RE: Saluda Restrooms- **ADDENDUM #1**

SALUDA RESTROOMS

ADDENDUM DRAWING #1

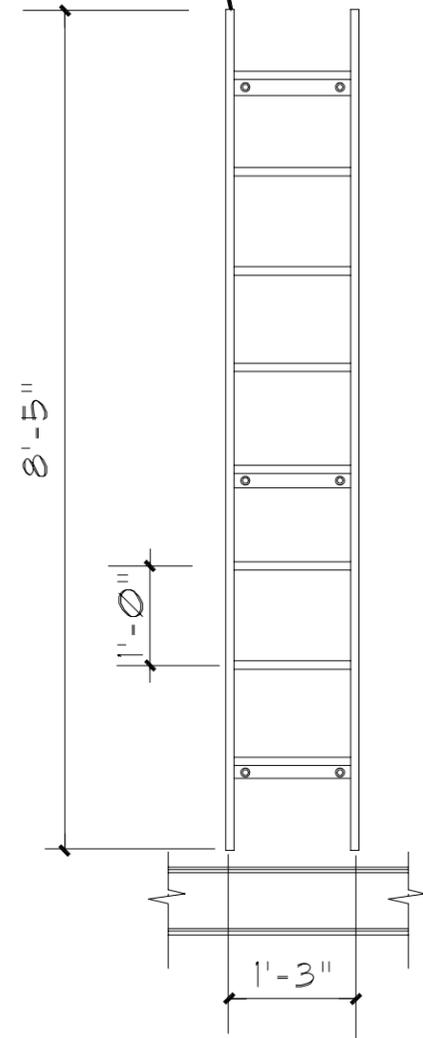
11. Please verify we are to use a 6"x6" field quarry tile as base per the details on sheet A1 seen below and the finish schedule on sheet A3. A quarry tile cove base is 5"x6" and the details do not show a cove base.

The quarry tile cove base should be included in the Scope of Work.

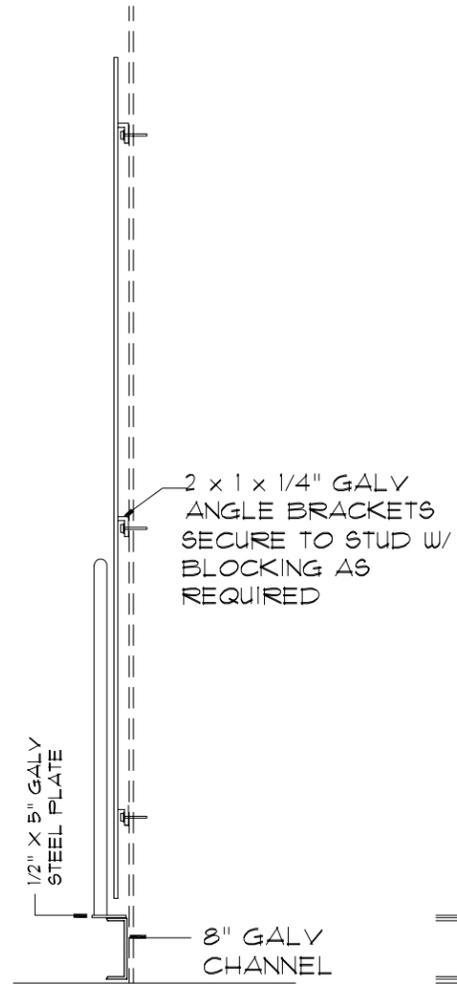
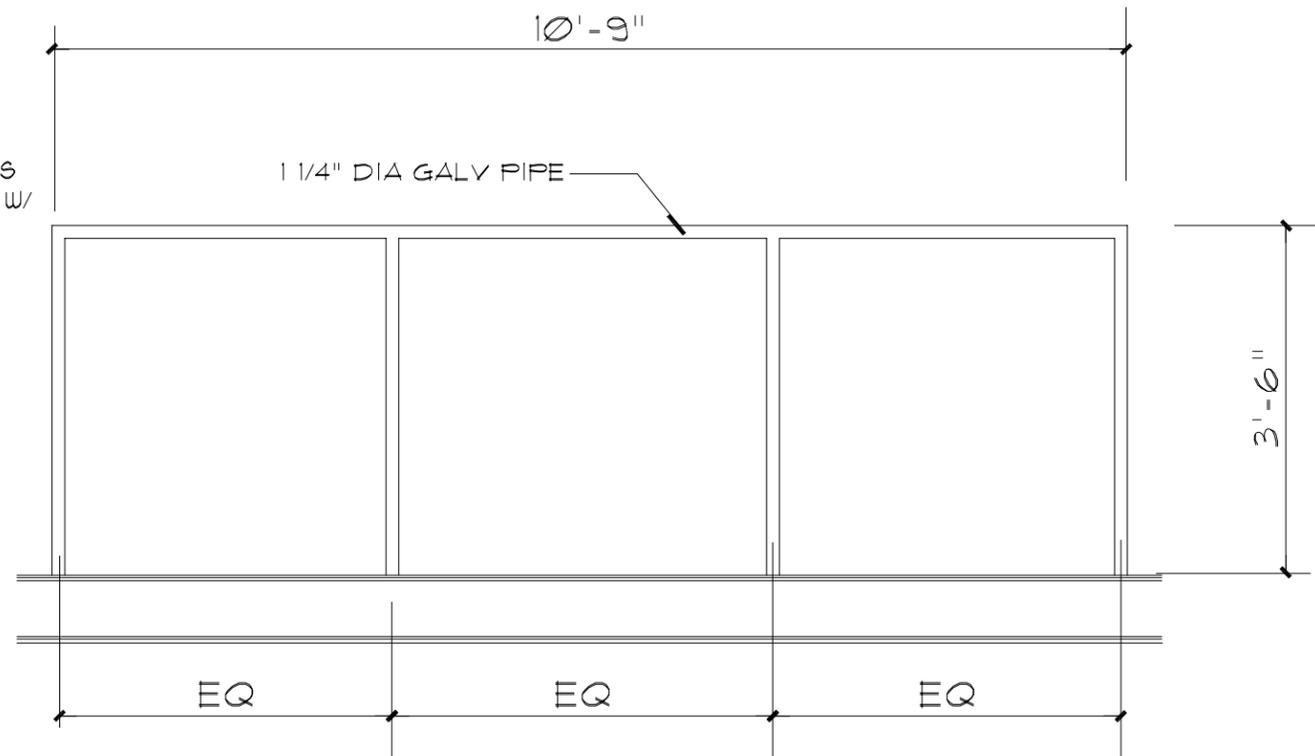
6. Are there any specifications for the decorative steel ladder & railing other than what is shown on the plans?

See attached Addendum Drawing #1.

NOTE: ALL GALVANIZED STEEL TO BE PRIMED AND PAINTED BLACK
